RESPONSE TO AN BORD PLEANÁLA OPINION PROPOSED STRATEGIC HOUSING DEVELOPMENT

NO. 2 FIRHOUSE ROAD AND THE FORMER 'MORTON'S, THE FIRHOUSE INN', FIRHOUSE ROAD, DUBLIN 24

PREPARED FOR:
BLUEMONT DEVELOPMENTS
(FIRHOUSE) LIMITED

June 2022

Areas to be taken in charge

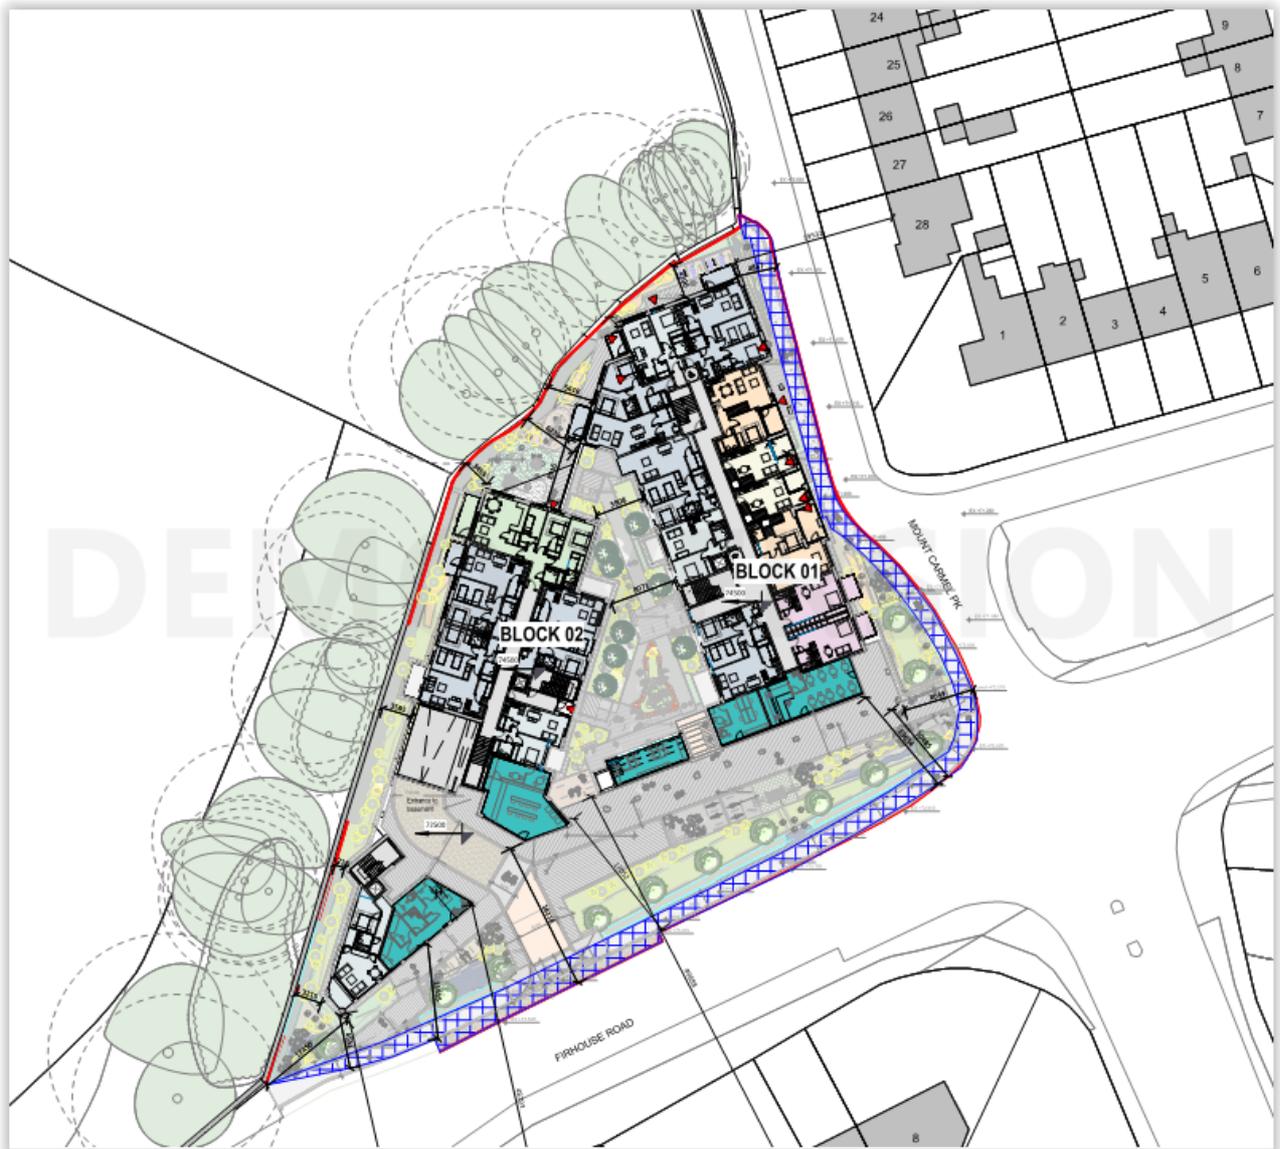
'A site layout plan indicating what areas, if any, are to be taken in charge by the planning authority.'

The extent of the areas to be taken in charge are hatched blue below and consist of a two metre wide footpath along Firhouse Road and Mount Carmel Park.
